**METROPOLITAN GOVERNMENT OF NASHVILLE AND DAVIDSON COUNTY**

**STAFF RECOMMENDATION**  
**3637 Richland Avenue**  
**Lot 5, Richland Hall Development**  
**April 19, 2017**

**Application:** New construction—infill and outbuilding; setback determination

SITE PLAN

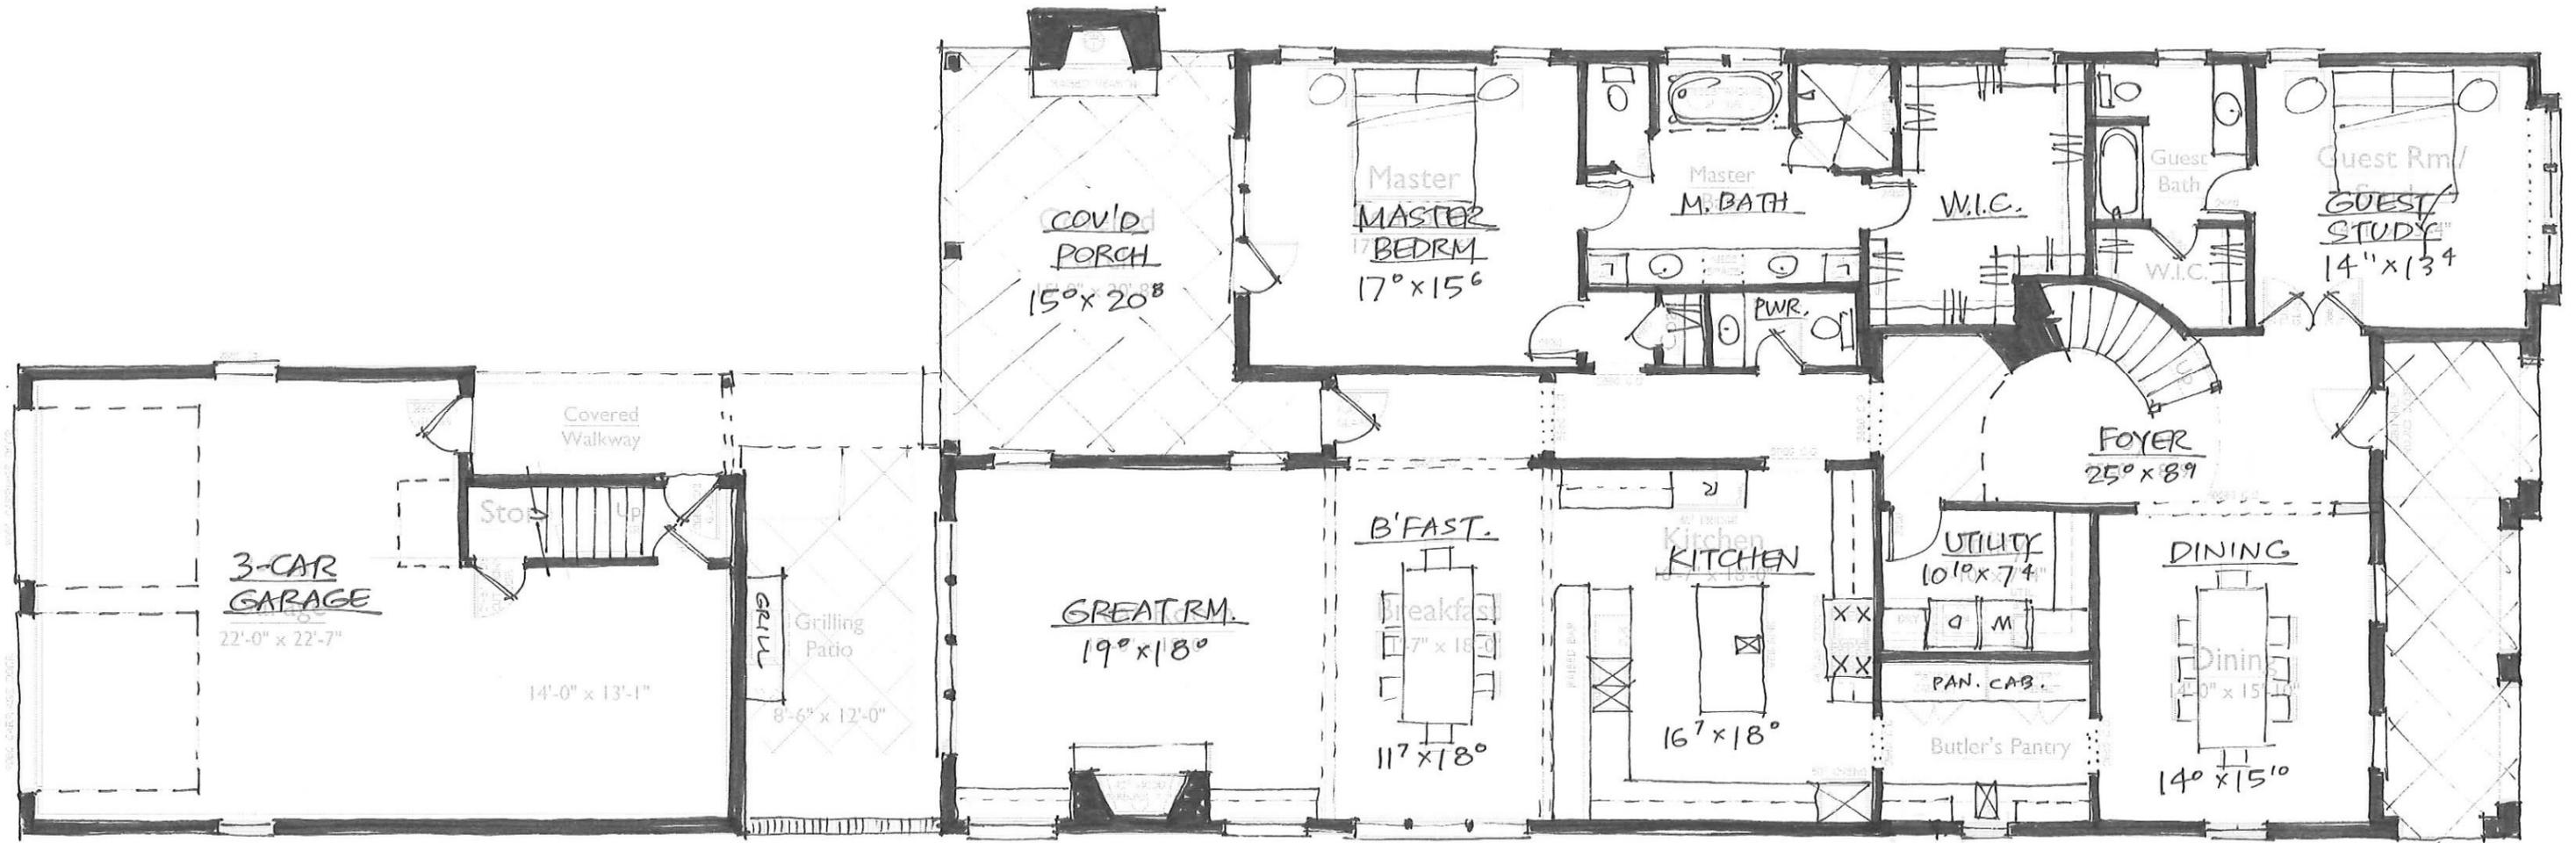
The right side elevation will be seven feet (7') from the side property line, which meets the base zoning setback of five feet (5'). On the left side, base zoning requires a five foot (5') side setback, but the applicant is proposing to set the infill just three feet (3') from the side property line. Staff finds this reduced side setback to be appropriate because there are other homes in the immediate vicinity that do not meet the required five foot (5') side setback. In addition, the infill is part of a larger development, and the reduced setback will affect the parcel next door at 3633 Richland Avenue, which is also part of the larger development. Staff has yet to review the site plan for 3633 Richland Avenue, but has directed the applicant that the right side of 3633 needs to be set more than seven feet (7') from the side property line. This will ensure there is at least ten feet (10') in between nos. 3637 and 3633 Richland Avenue and that the reduced side setback will not affect overall rhythm of spacing on the street. For Lots 1, 2, 3, and 4 of this development, the Commission has approved similar setback determinations.

The Commission typically requests to see at least twenty feet (20') between the primary structure and the outbuilding. The applicant is proposing just ten feet (10') in between the structures. The Commission has approved the distance of ten feet (10') in between the primary structures and the outbuildings for Lots 1, 2, 3 and 4 of this development, and staff recommends that it be approved for Lot 5. The overall development is creating a new alley at the rear of the lots, which will make the back portion of the lot unavailable for building. Approximately the back thirty feet (30') of the lot is used for the alley. In addition, there is a utility easement in between the alley and the outbuilding. The outbuilding cannot be pushed any further to the rear because of the new alley and the easements on the property. Therefore, staff finds that the distance in between the primary house and the outbuilding to be sufficient.

Base zoning requires that outbuildings larger than seven hundred square feet (700 sq. ft.) be located twenty feet (20') from the rear property line and five feet (5') from the side property lines. The outbuilding will be more than twenty feet (20') from the rear property line, although it will appear to be much closer because the rear portion of the lot will be dedicated to a new private alley. The outbuilding will meet the right side setback, but will require a side setback determination left side property line. It will be just three feet (3') from the left side property line rather than the required five feet (5'). Staff finds the proposed three foot (3') side setback to be appropriate because it will line up with the setback of the proposed infill. In addition, historically, outbuildings were located close to or on the side property lines.

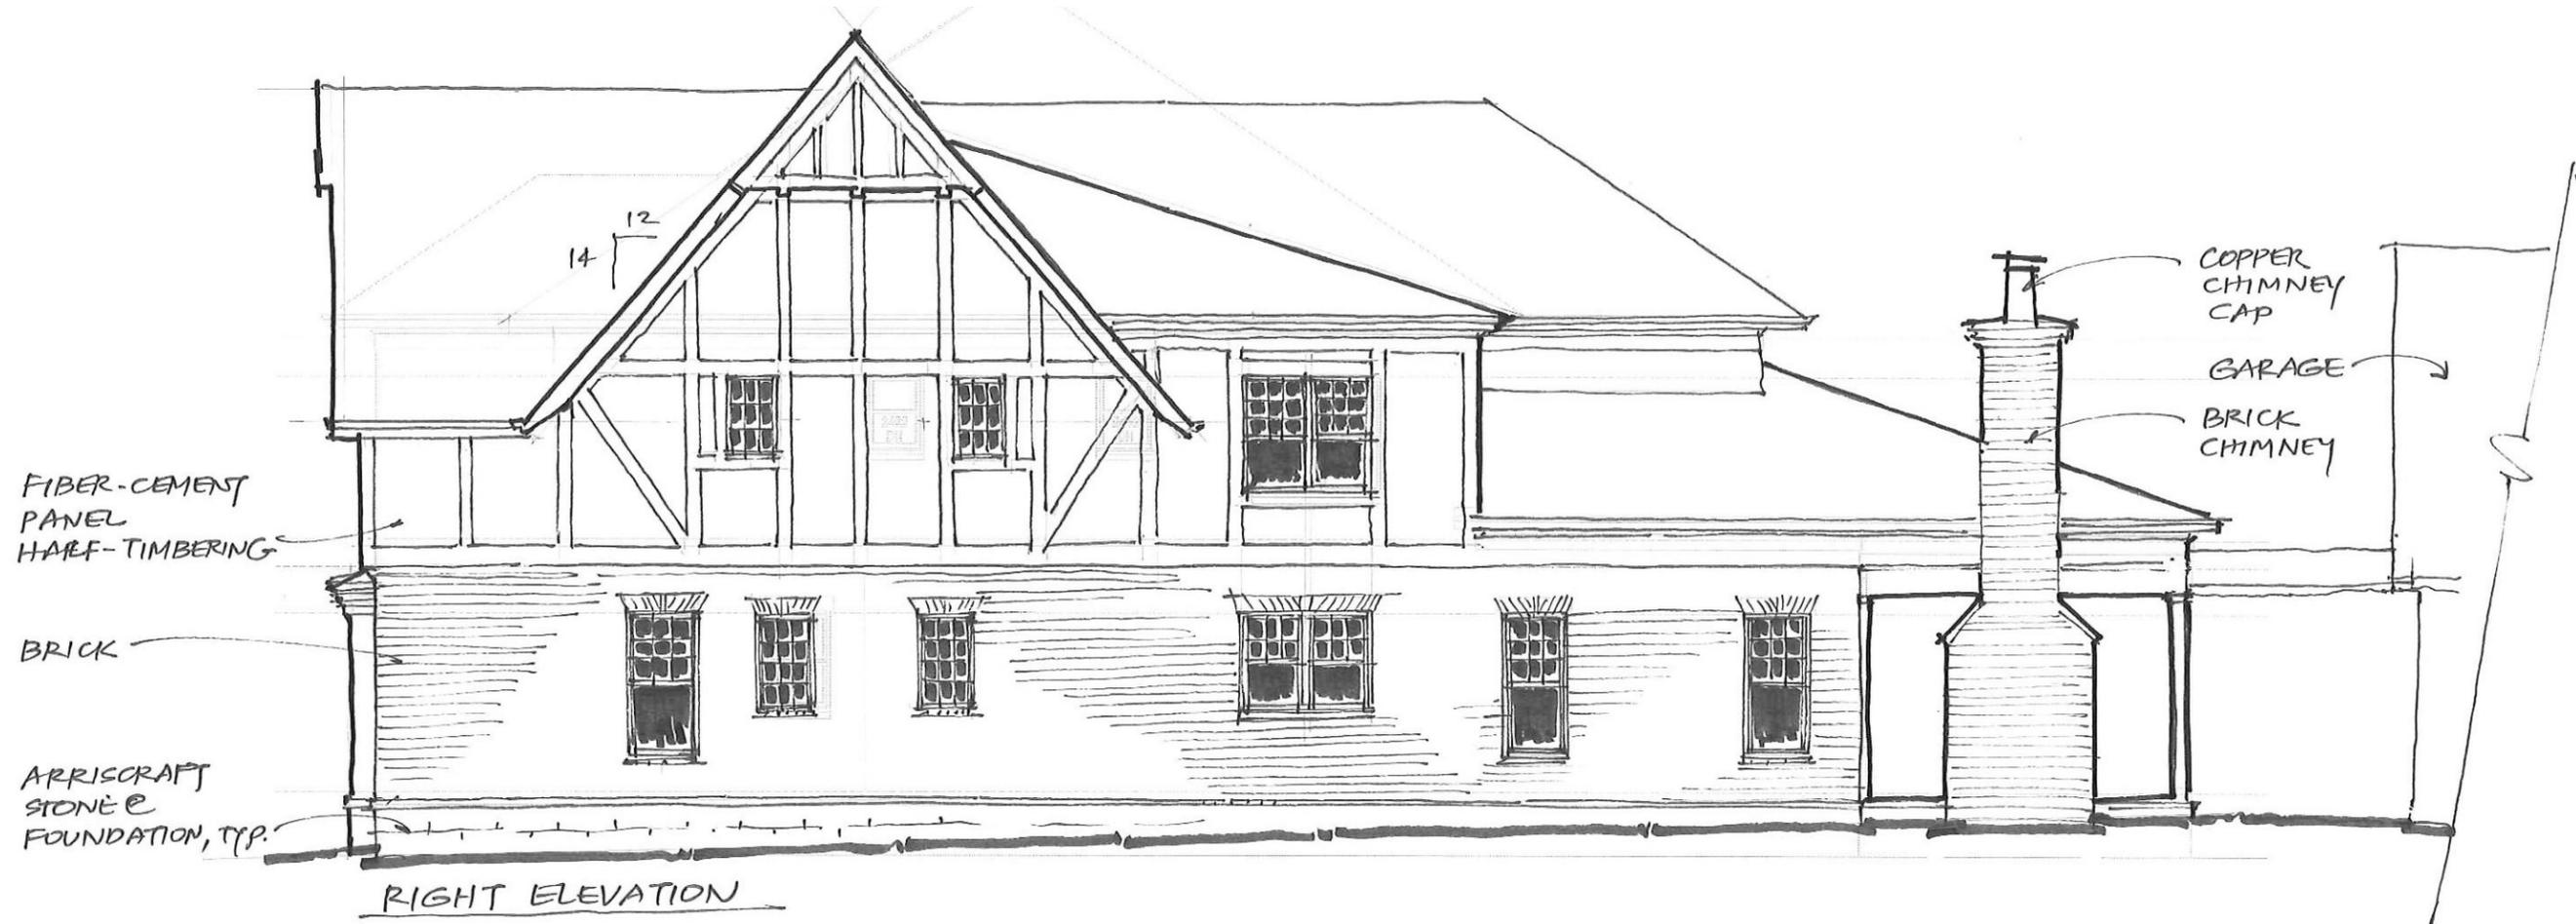
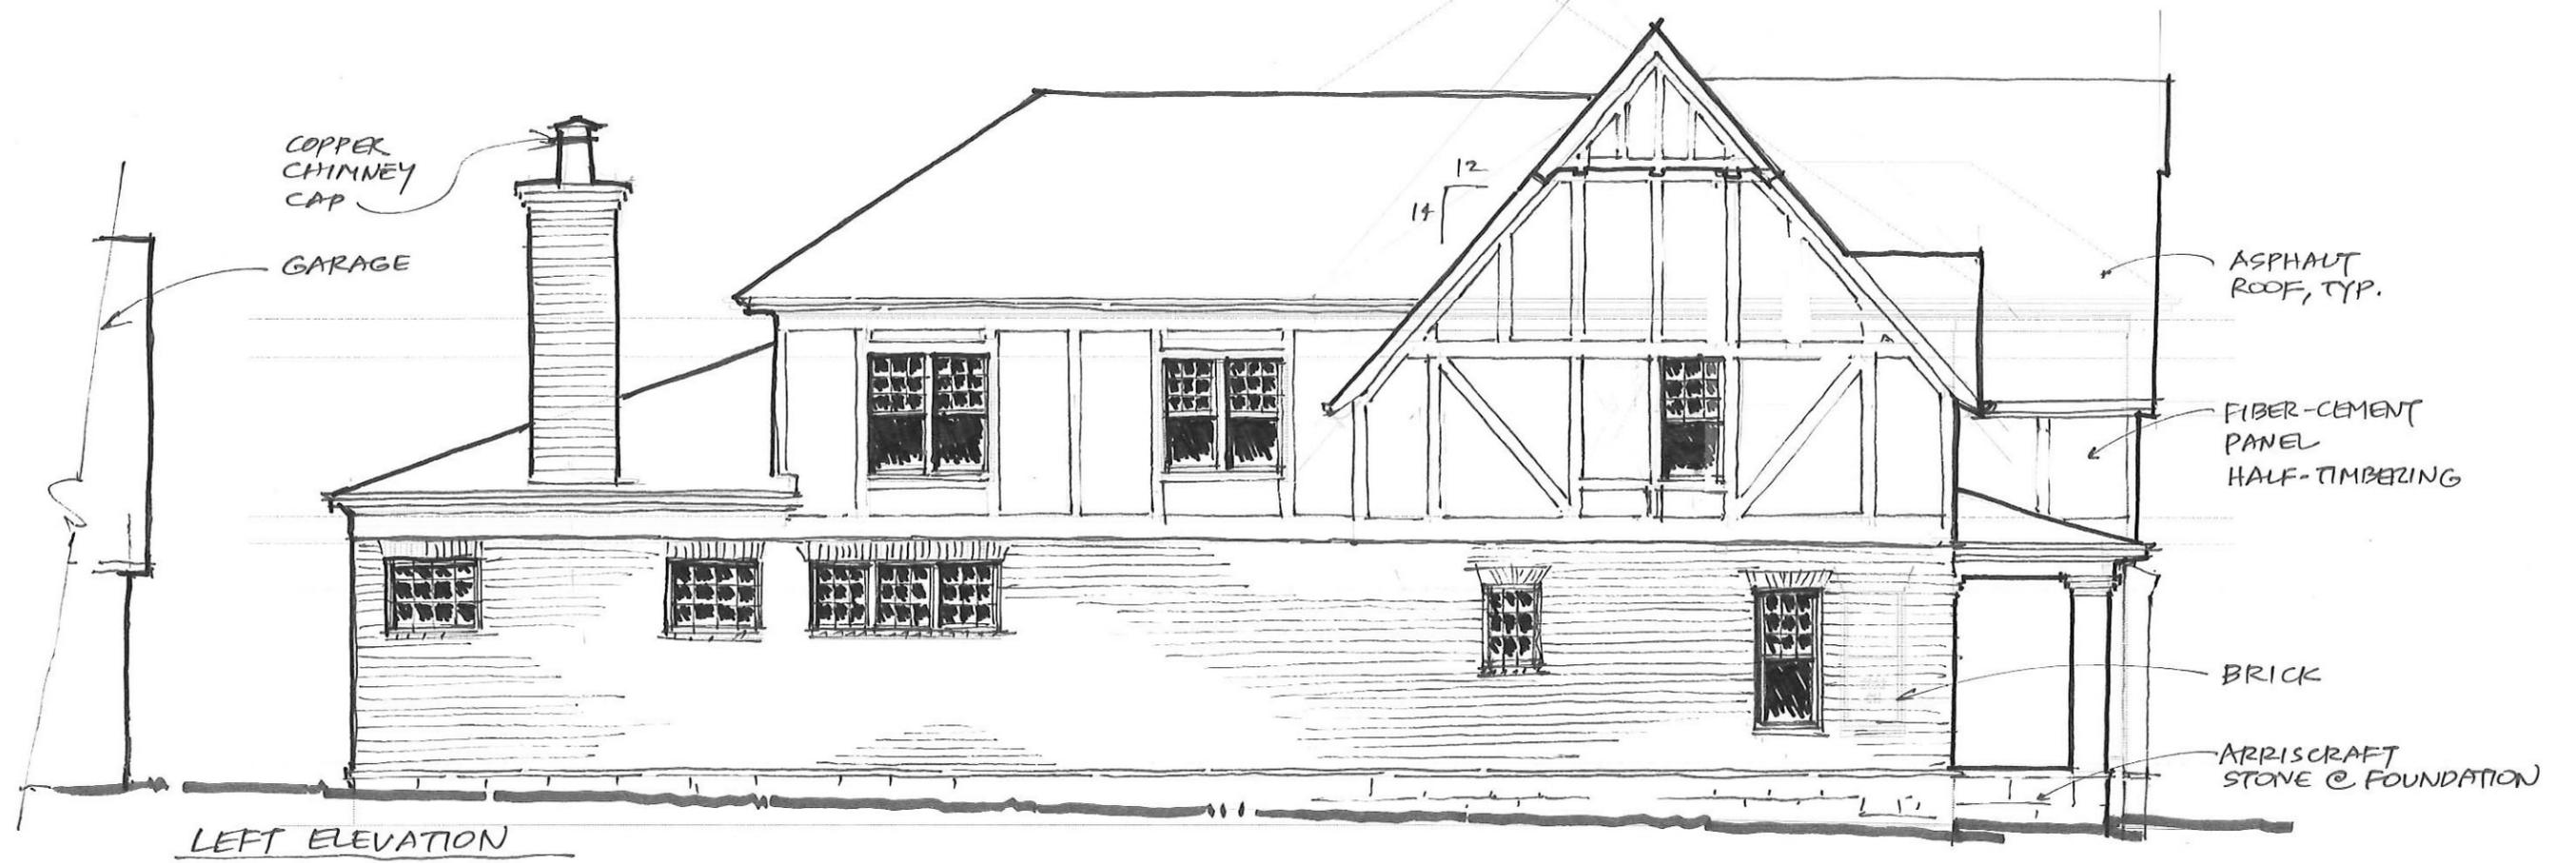
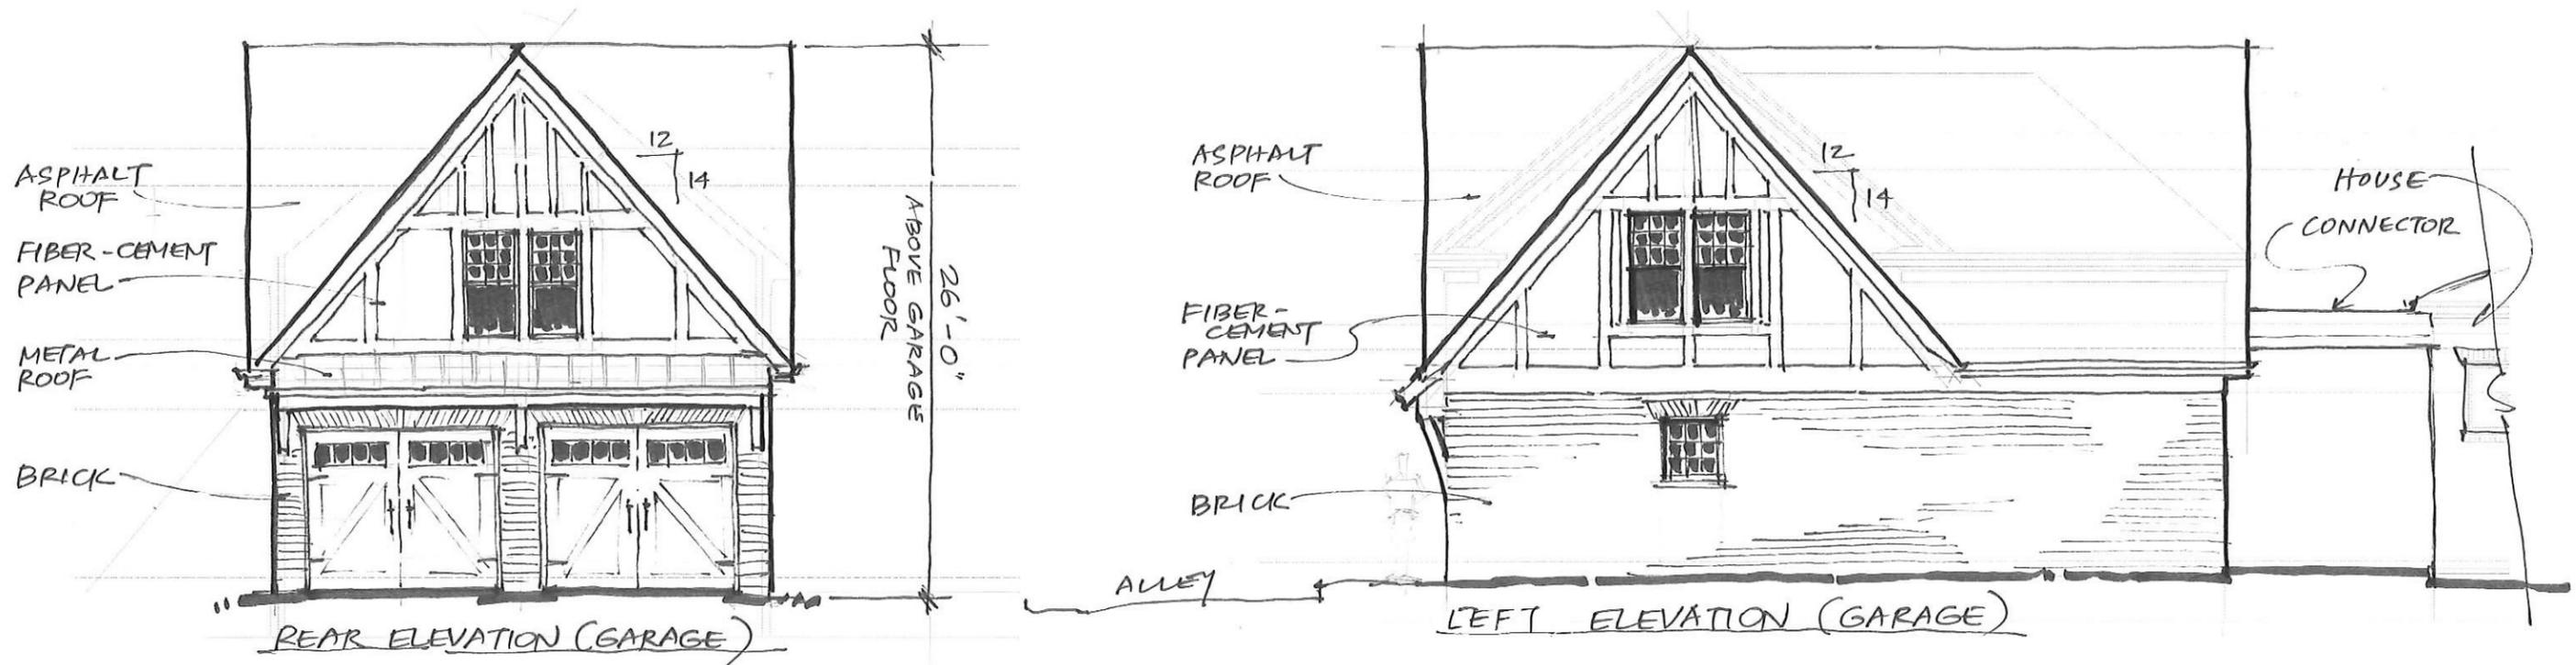
\*The drawings show the outbuilding as being twenty-six feet (26') tall, but the design guidelines limit outbuildings to twenty-five feet (25') tall. Staff recommends that the outbuilding height be reduced so that it is no taller than twenty-five feet (25').
